**Regulatory Proposal to AER 2015 - 2020**

**Review of Proposed Capital  
Expenditure in Energex's Revised  
Regulatory Proposal**

**Report to  
Australian Energy Regulator  
from  
Energy Market Consulting associates**

**September 2015**

Figure 1: LV fusing program by RCP<sup>11</sup>

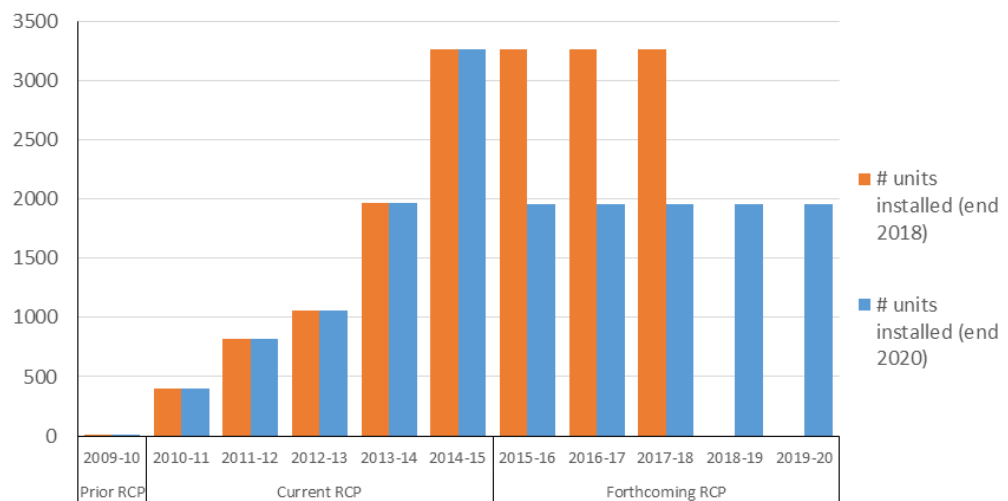
47. We show the change in strategy adopted by Energex diagrammatically in Figure 1 below. Energex's original program (until c.2013) was based on installing approximately 2,000 LV fuses per annum, with program completion by 2020. The revised program (from c.2014) proposes continued installation of 3,269 units per annum (to reflect 2014/15 performance) for the remainder of the RCP, with program completion by 2017/18.

50. We consider that Energex should:
  - (i) Prioritise its installation program on the basis of risk (highest to lowest);
  - (ii) Continue to apply existing mitigation measures such as its public awareness campaign, vegetation management, fitting of LV spacers, rapid response to wires-down reports, and a conductor replacement program;<sup>12</sup> and

Figure 2: WPF SAIDI performance trends – rural and urban feeders

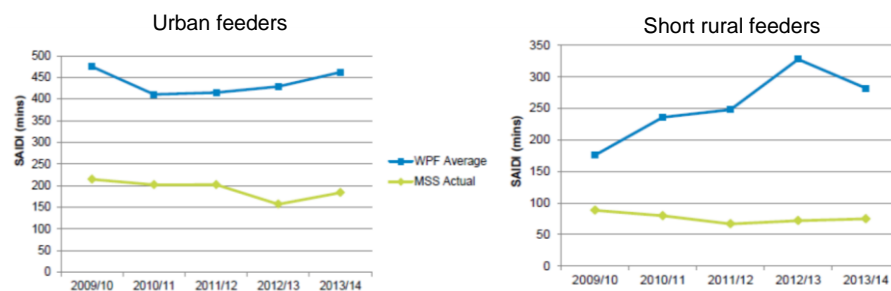
59. Energex also provided trend of average WPF performance as shown in the two graphs below. The trends show that despite stated WPF expenditure of \$47m in the 2010-15 RCP, average rural WPF performance has deteriorated.

Figure 3: Worst performing feeders and projects 2010-2015<sup>22</sup>

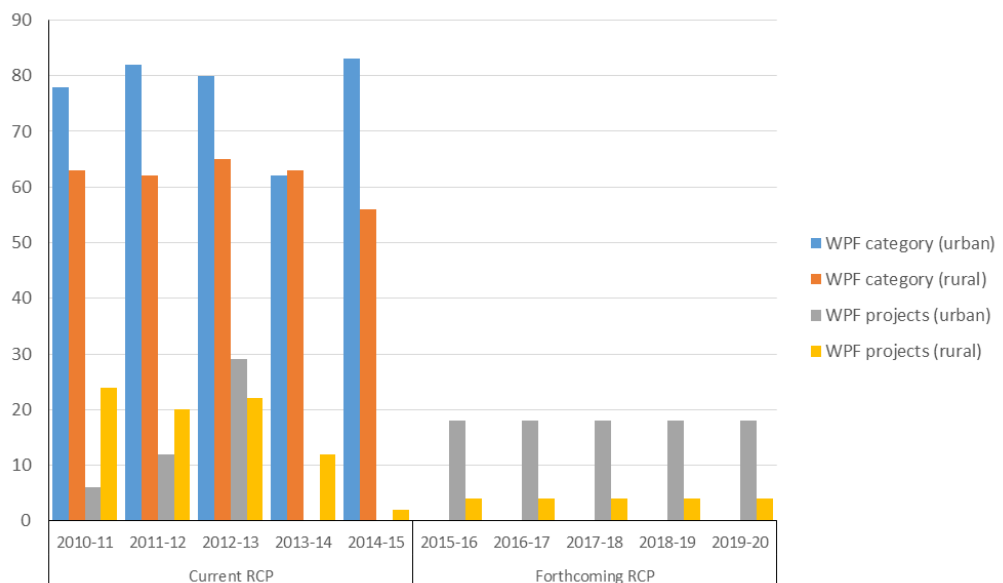
60. We consider that a reasonable interpretation of the purpose of the DA improvement program to “enable customers with the worst reliability outcomes to benefit from tailored network performance”<sup>20</sup> is for Energex to focus on the ‘worst of the worst’ performing feeders and that in determining the number of WPF to be addressed, consideration be given to maintaining the relative performance of the population of WPFs.
61. In Figure 3 below, we show Energex’s WPF program over the current RCP alongside the forecast WPF program over the forthcoming RCP. In the current RCP, Energex included 117 projects at an average of 23 feeders per annum. We were unable to find evidence to support the apparent decline in the number of projects completed in the final two years of the current RCP.<sup>21</sup>

Figure 4: Asset category expenditure profile - 'Other' repex

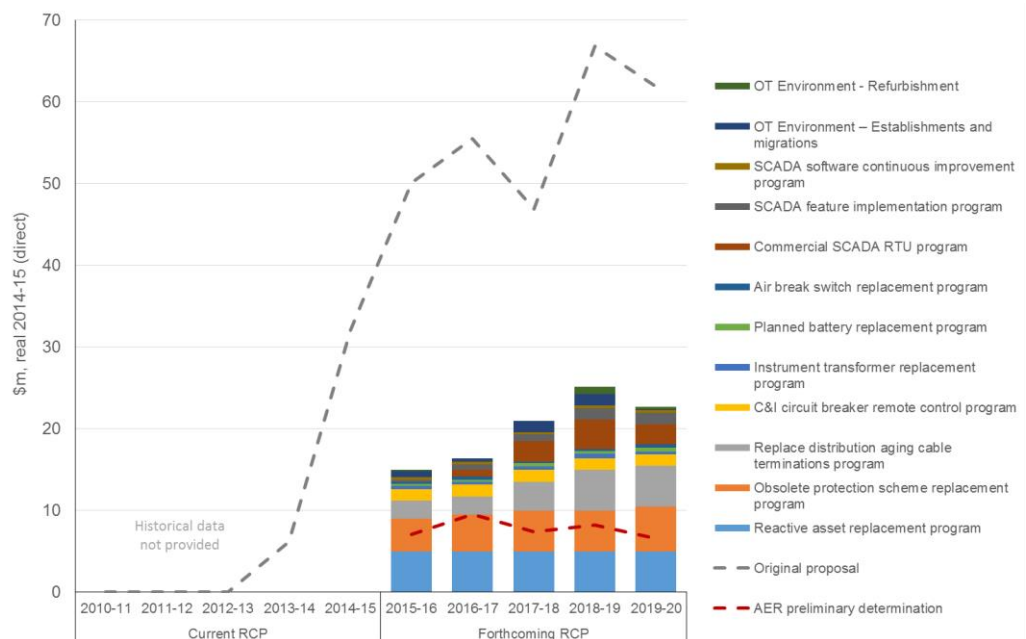
110. In Figure 4 below, the repex for the 'Other' asset category that Energex proposed in its RRP is compared with the allowance it proposed in its original RP and with the allowance in the AER's preliminary determination.

111. Energex provided only two years of historical/estimate data for the years 2013-14 and 2014-15 totalling \$38m in its original RIN submission. The AER relied on this data to establish its historical level of expenditure. Energex did not provide historical actual/estimate data for this asset category in its RRP RIN submission.
112. We reviewed a sample of programs nominated in Table 7 to form a view as to whether Energex has provided sufficient information to support the program now proposed and to identify any systemic issues that may lead us to form a view that its proposed allowance is not reasonable, in terms of the relevant NER criteria. We note that the revised forecast expenditure profile indicates an increasing trend over the RCP. This is primarily driven by increases in: (i) the proposed aging cable terminations program; and (ii) the proposed commercial SCADA RTU program.

Figure 5: Asset category expenditure profile SCADA repex

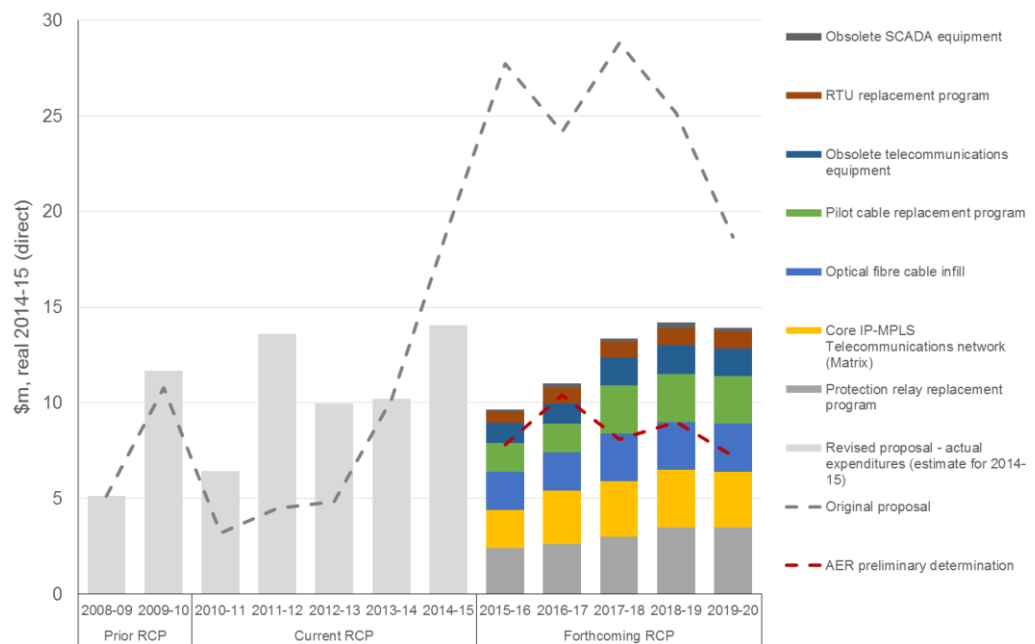
137. In Figure 5, the asset category repex for SCADA, network control and protection systems now proposed by Energex in its RRP is compared with the allowance it proposed in its original RP and with the allowance in the AER's preliminary determination.

138. We have shown the original proposal and the revised proposal historical actuals and forecast expenditure in the figure above. Energex provided different historical actuals for this asset category in its RRP when compared with its original submission in its RP, showing an increase of approximately \$12m over the current RCP. The difference is primarily driven by a higher expenditure in 'Communication Network Assets' of approximately \$15m over the current RCP. Energex categorised this asset category differently in the RIN for its historical/estimates; therefore, we have only provided the aggregate figures for comparative purposes with its RRP.

139. The revised forecast expenditure profile reflects an increasing trend over the RCP, from a starting point that is approximately equal to the average over the current RCP. The increasing trend is primarily driven by increases in the: (i) protection relay replacement program; (ii) pilot cable replacement program; and (iii) replacement of obsolete telecommunications equipment.
